# Access Compliance Report

## Public Rights-of-Way

### (Curb Ramps)

Intersection ID: 49250	Main Street: RIDGE_PATH_LN	Cross Street: BOOMERANG_WY	Location: S
ADA ID: FCB9CD90C60D	Ramp Type: BlendTrans1	Initial Pass/Fail: Fail	Overall Compliance: No
		Severity Score: 8.75

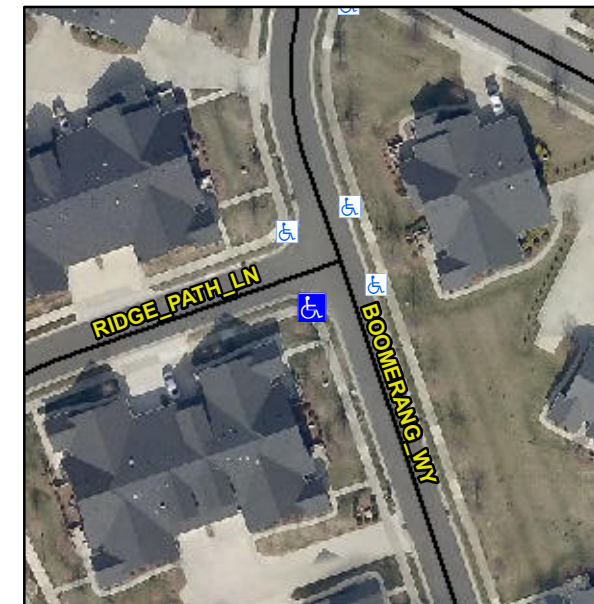
**Not Found, R304.5.1**

Compliance	Description	Data	Compliance	Description	Data
N/A	Ramp Length (in)	47.0	Yes	BlendTrans Slope (%)	3.8
No	Ramp Width (in)	47.0	Yes	BlendTrans XSlope (%)	1.2
N/A	Flare Type LT	N/A	N/A	Flare Type RT	N/A
N/A	Flare Slope LT (%)	N/A	N/A	Flare Slope RT (%)	N/A
N/A	Flare Traversable LT?	N/A	N/A	Flare Traversable RT?	N/A
N/A	Landing Length (in)	N/A	N/A	DWS Provided?	N/A
N/A	Landing Width (in)	N/A	N/A	DWS Contrast?	N/A
N/A	Landing Slope (%)	N/A	N/A	DWS Length (in)	N/A
N/A	Landing X Slope (%)	N/A	N/A	DWS Full Width?	N/A
N/A	Landing Curb? (Y/N)	N/A	N/A	DWS Offset (in)	N/A
N/A	Shared Landing?	N/A			
N/A	Gutter Ponding?	N/A	N/A	Gutter Slope (%)	N/A
N/A	Gutter Lip Ht (in)	0.5	N/A	Gutter X Slope (%)	N/A
N/A	Painted X Walk1?	No	N/A	Painted X Walk2?	No
	X Walk 1 Direction	To NE		X Walk 2 Direction	To NW
	X Walk 1 Width (in)	N/A		X Walk 2 Width (in)	N/A
	X Walk 1 Slope (%)	2.9		X Walk 2 Slope (%)	2.8
	X Walk 1 X Slope (%)	0.1		X Walk 2 X Slope (%)	0.0

N/A	Ramp inside XWalk1?	N/A	N/A	Ramp inside XWalk2?	N/A
	Road Slope (%)	0.1		Clear Space?	N/A
	Road X Slope (%)	2.9	N/A	Clear Space to XWalk (in)	N/A
N/A	Any Obstructions?	N/A	N/A	Storm Grate/Utility Hazard?	N/A
	Obstruction Type			Storm Grate/Utility Type	
		N/A			N/A
			Yes	Surface Condition? (G/P)	Good
			No	Curb Slope (%)	18.2

**Remove & Replace Curb Ramp With Two New Directional Ramps or Equivalent.**
